Environmental
Assessment - S75W
Western Building

SYDNEY SUPERYACHT MARINA MP09_0165

S75W modification to consent MP-09_0165 under the former Part 3A of EP & A Act

This modification application under the former s75W of the Environmental Planning and Assessment Act 1979 (EP & A Act), seeks relatively minor amendments to the approved consent MP09_0165 dated 26 November 2012 in respect of Sydney Superyacht Marina at 2 Maritime Court Rozelle. The modifications almost exclusively relate to the western building of the consent for which a construction certificate has been provided and include:

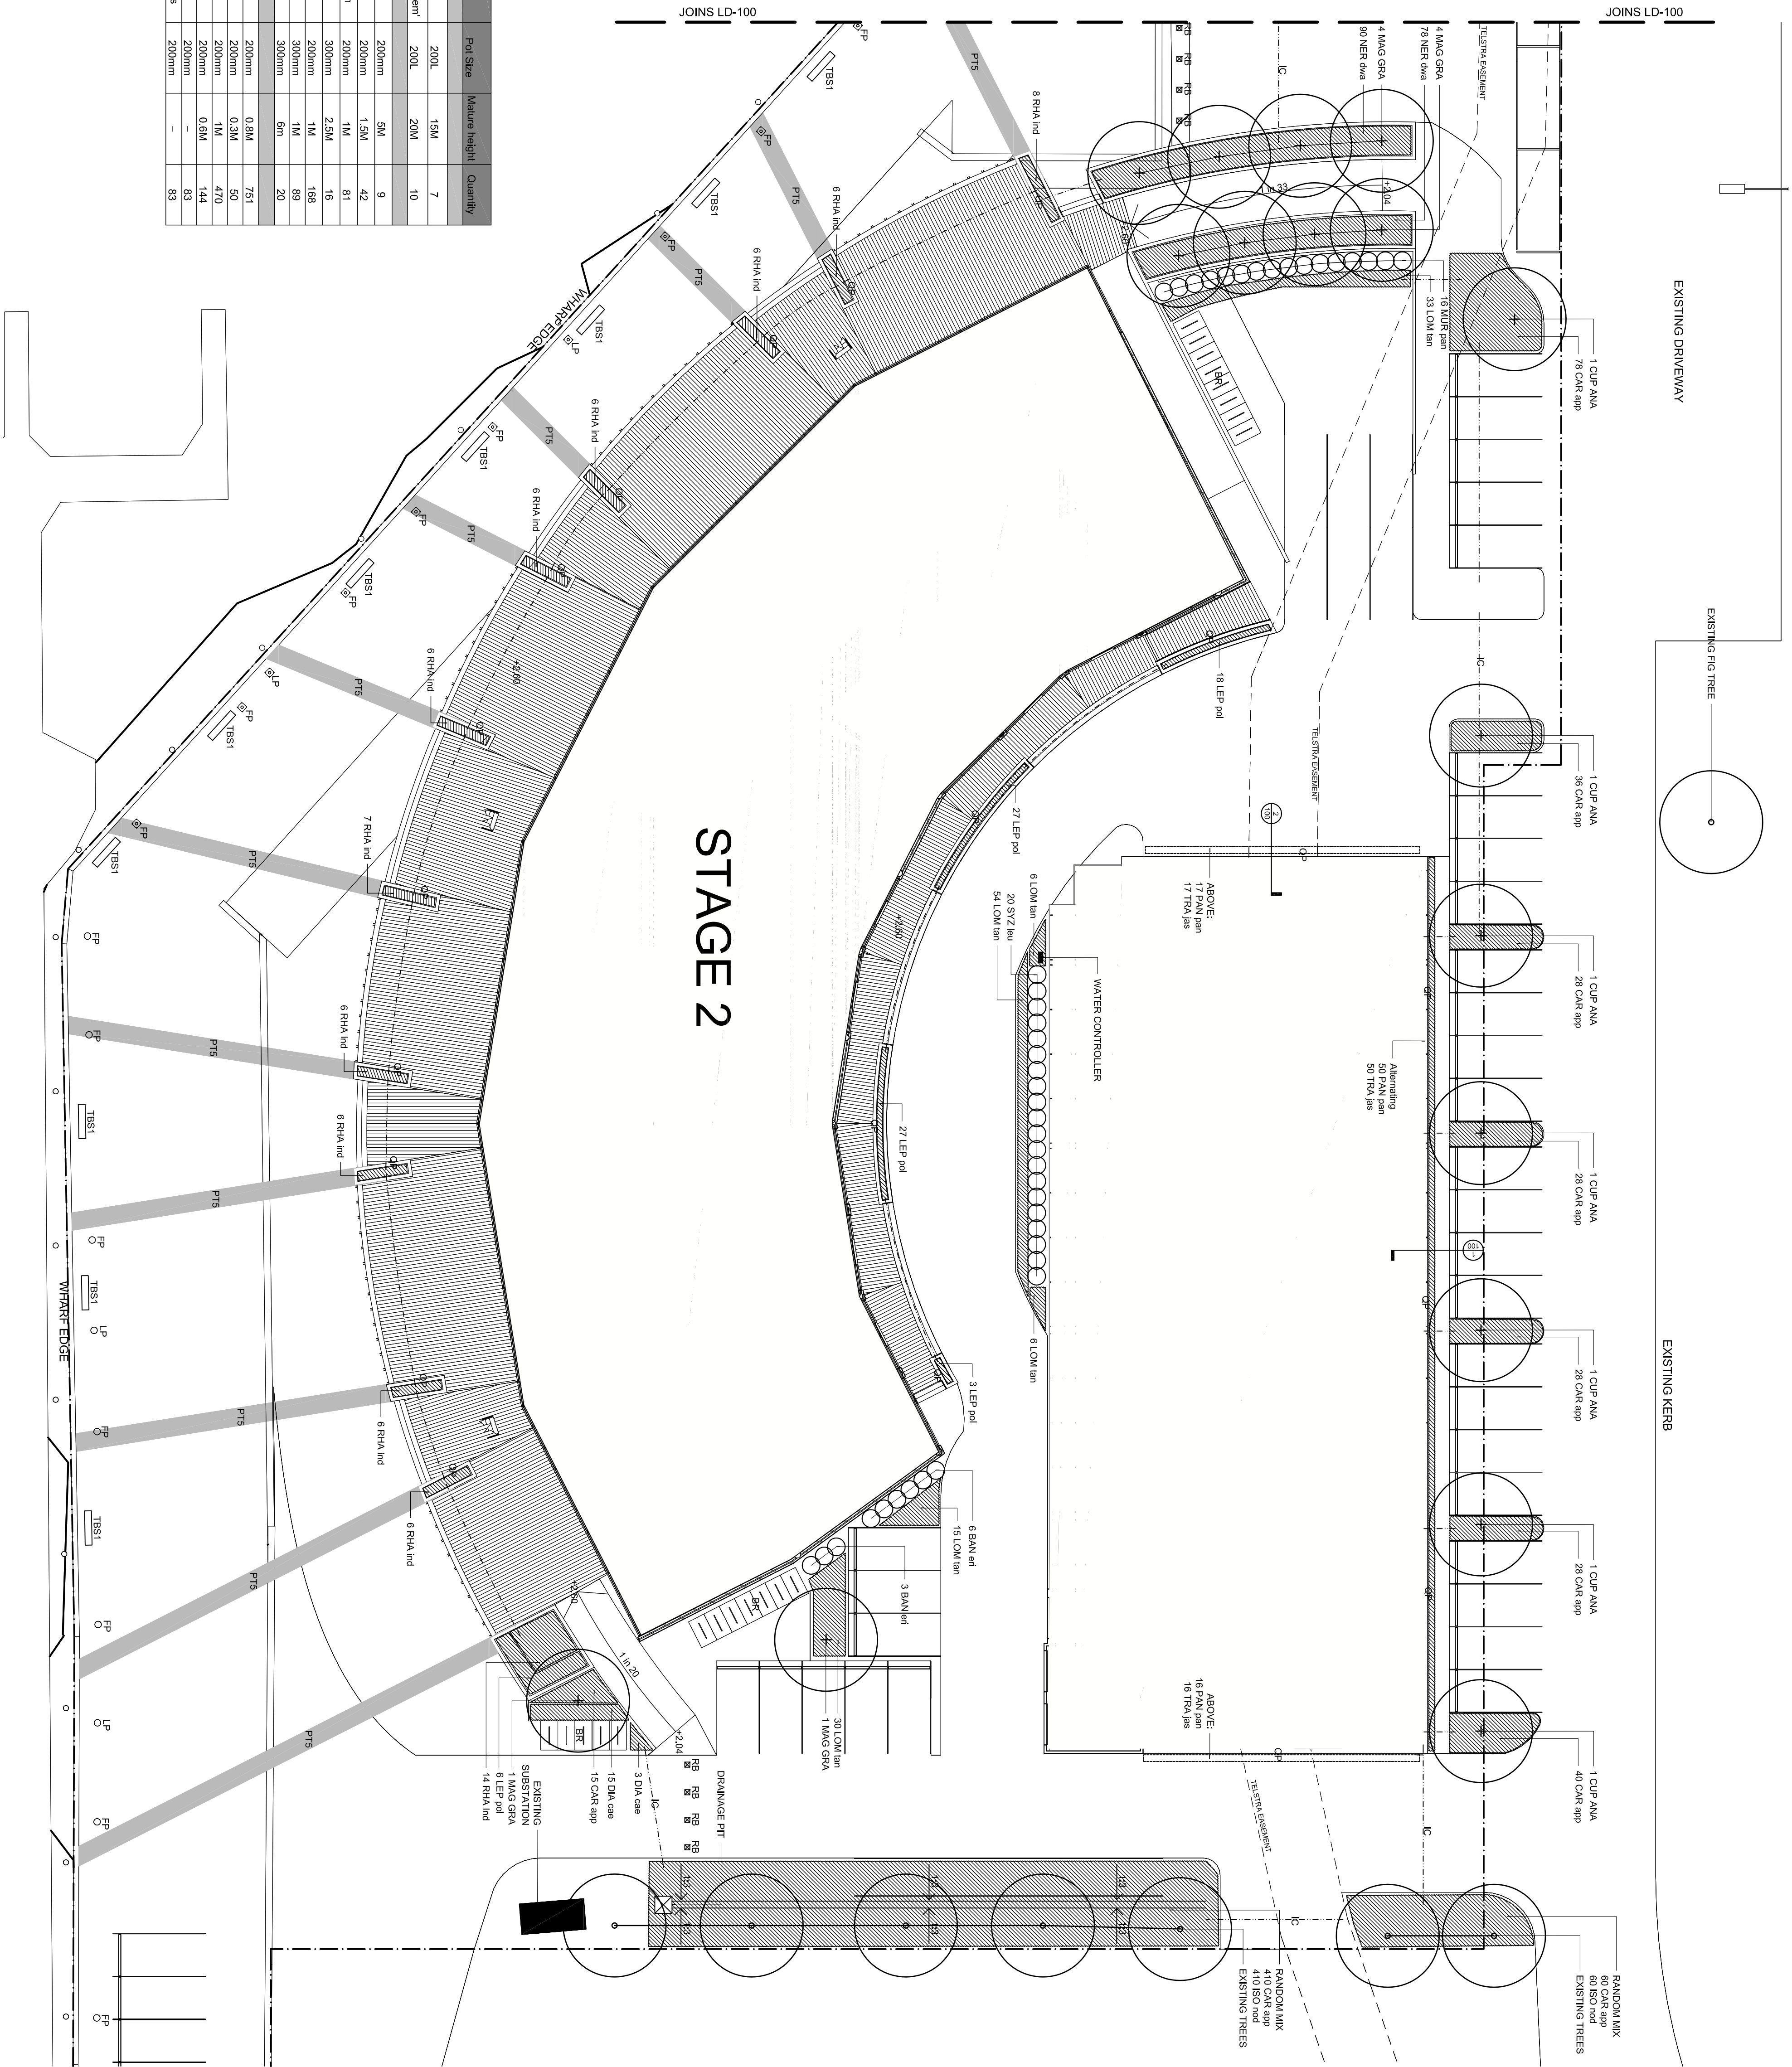
Condition B2 of the Consent required the approval by the Director-General of a landscape plan prior to the issue of a construction certificate. Approval to that was provided by letter dated 14 August 2013. As part of the submission of the landscape plan, a section indicating the reduction of the first floor balconies and roof overhang was provided to illustrate a consistent setback to the wharf edge. Sydney Superyacht Marina indicated that a s75W application would be made to rectify the alignment of the first floor and roof in accordance with that plan. **Appendix A** includes a copy of the letter and copies of the plans referred to in that letter. It is noted that the reference to L101 Rev 04 appears incorrect and it should in fact refer to plan L100 Rev 05. Both these plans and plan SK931C are attached.

The department has reviewed your submission including the accompanying plans: L 100 Rev.05 Stage 1 Landscape Plan dated 12/8/2013 and L 101 Rev.4 Stage 2 Landscape Plan dated 9/8/2013 prepared by Scott Carver Pty Ltd. These plans detail the design resolution of the landscape treatment for the site, as required by Condition B2 of the approval. In this regard, Plan L 100 Rev 05 appropriately shows the setout details for the site, including to confirm that the façade of the western building at ground floor level will be setback 10 metres from the wharf edge, with the deck projecting 3.5 metres within this area. The department notes that the design of the deck and the planters are sufficiently resolved.

Having regard to the above, I can advise, as the nominee of the Director-General in accordance with the delegations dated 5 July 2012, that the above referenced plans are approved and the terms of Conditions B2 and B6 have been satisfied with respect to Stage 1 of the project.
